Plan Commission Agenda
Monday, July 20, 2026 - 6:00 PM
Lake Geneva City Hall; Council Chambers

STAFF REPORT
To Lake Geneva Plan Commission
Meeting Date: July 20, 2026

FIRE TRUCK TURN EXHIBIT

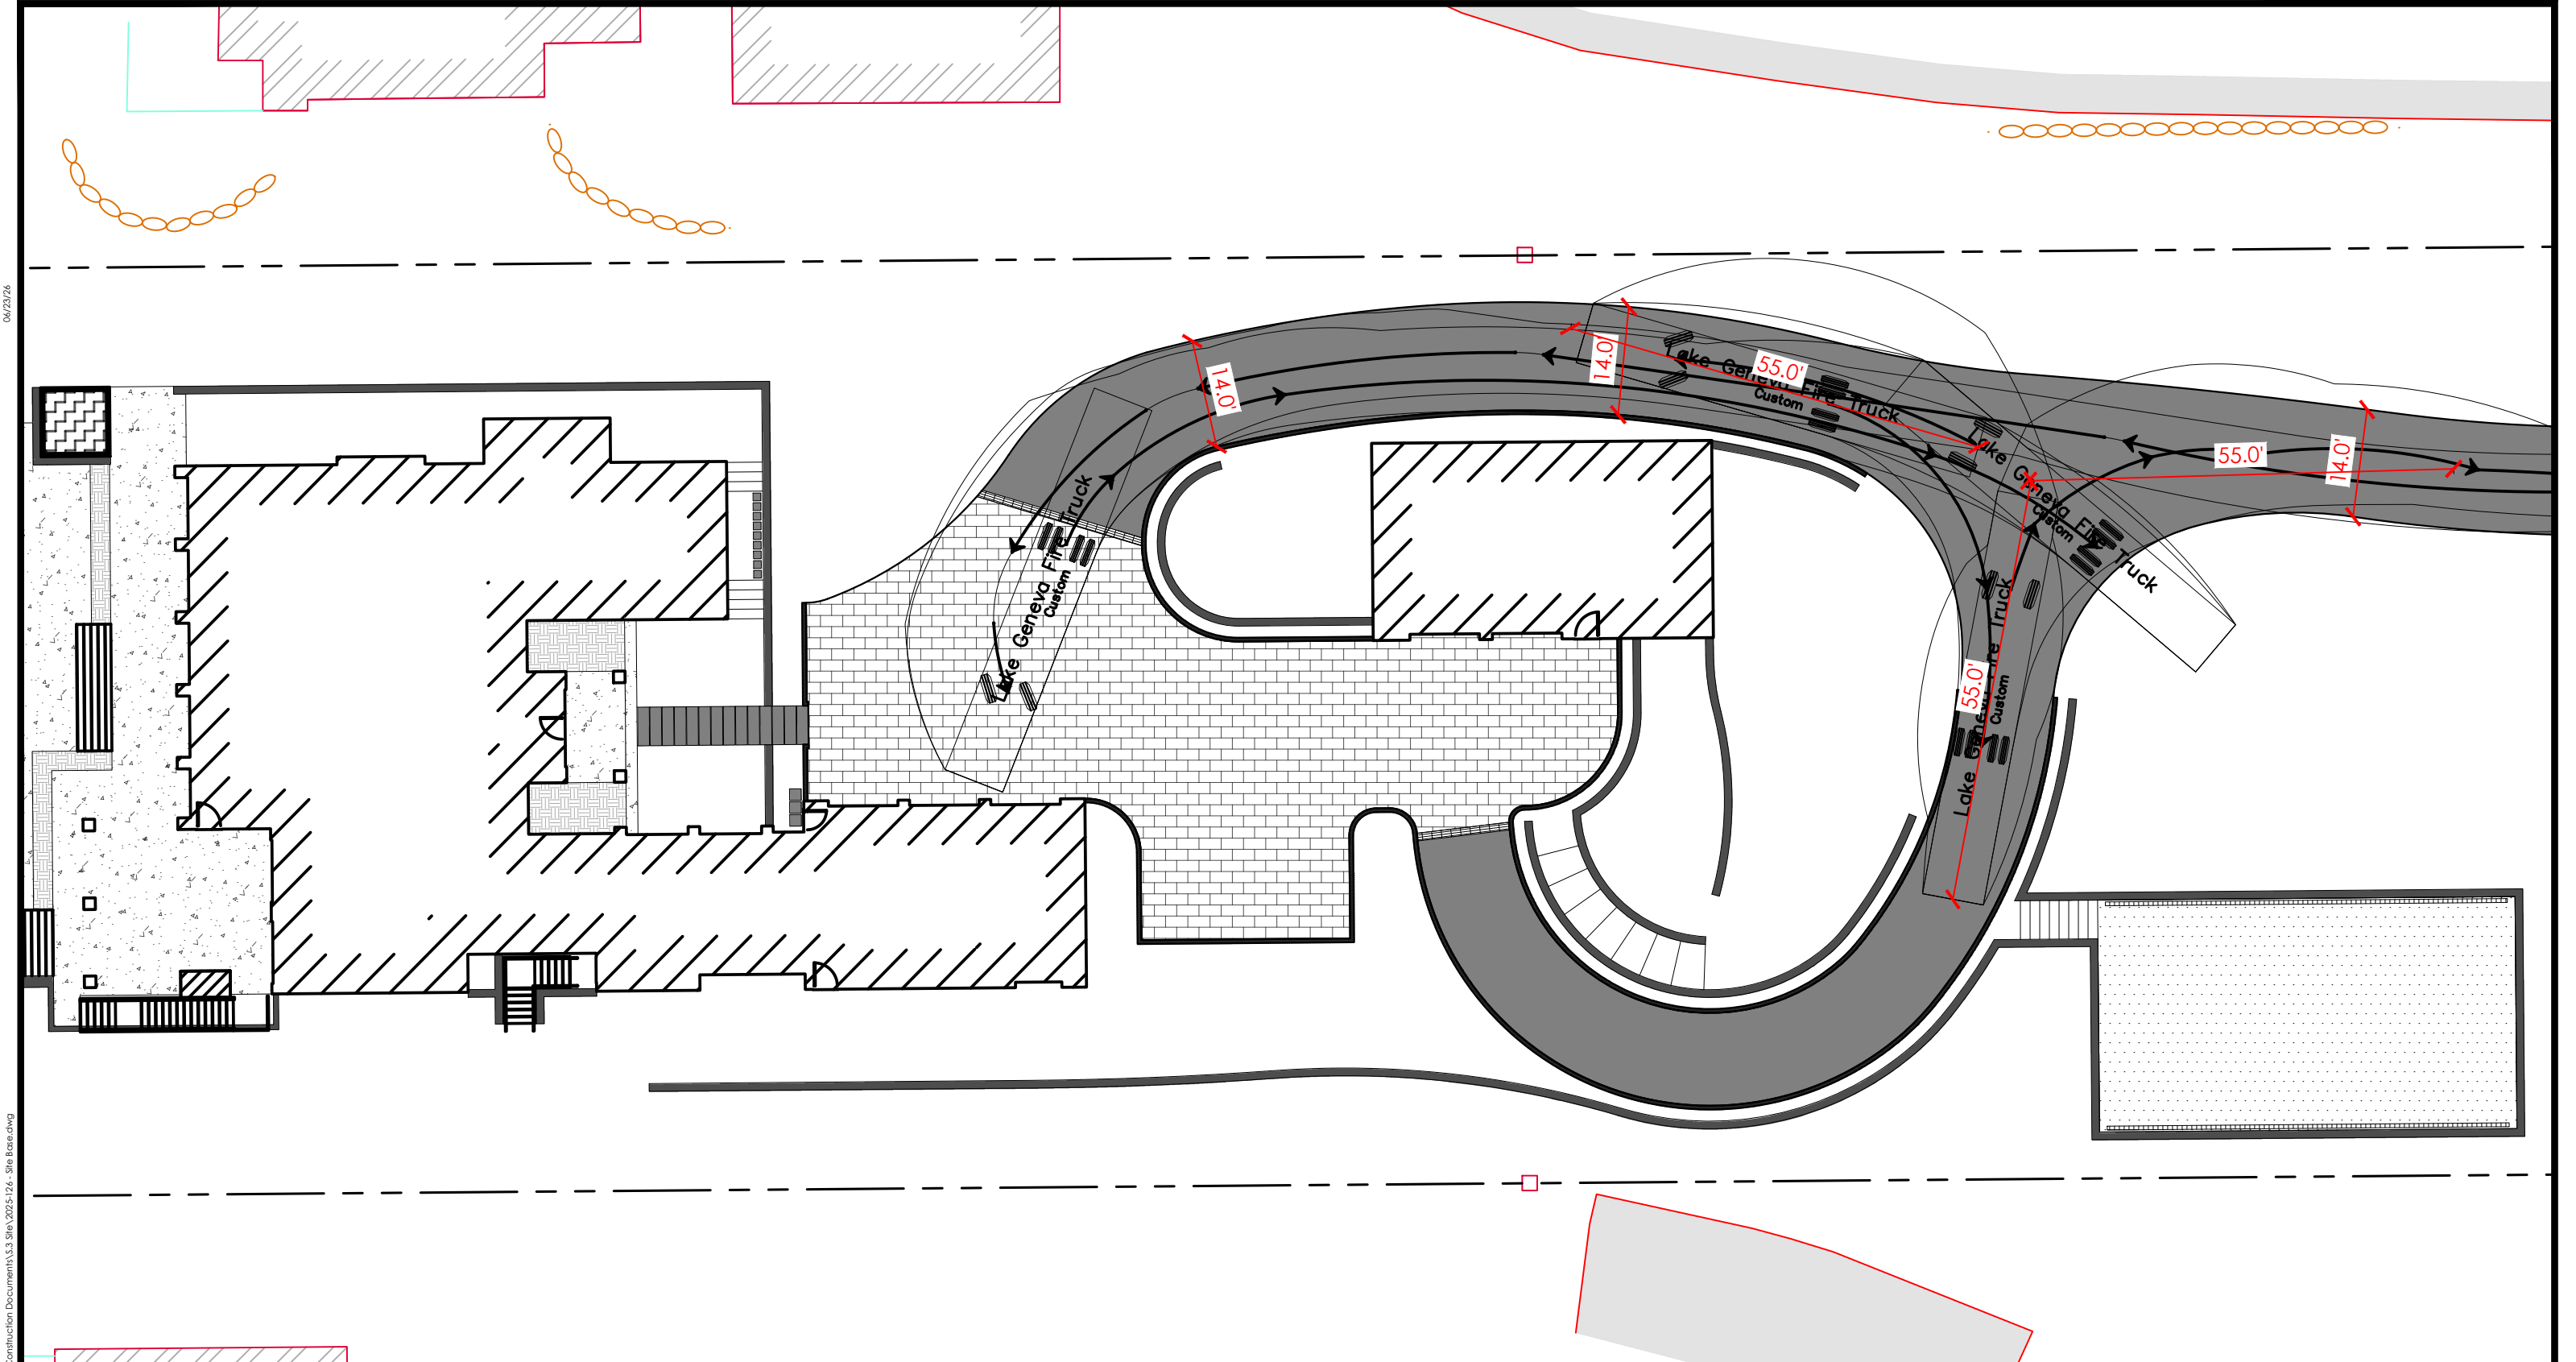
- b. All curves and turnarounds shall be designed for a minimum 45-ft radius. If the fire lane has a dead end that is greater than 150-ft, an appropriately designed turn around space approved by the City of Lake Geneva Fire Department is required.

Response: The attached exhibit with a "Y" turn around (each leg being at least 55 feet in length) within 150 feet of the single-family residence has been presented to the City Fire Chief, Dennis Detkowski. Verbal approval was received from the City Fire Chief on June 23, 2026.
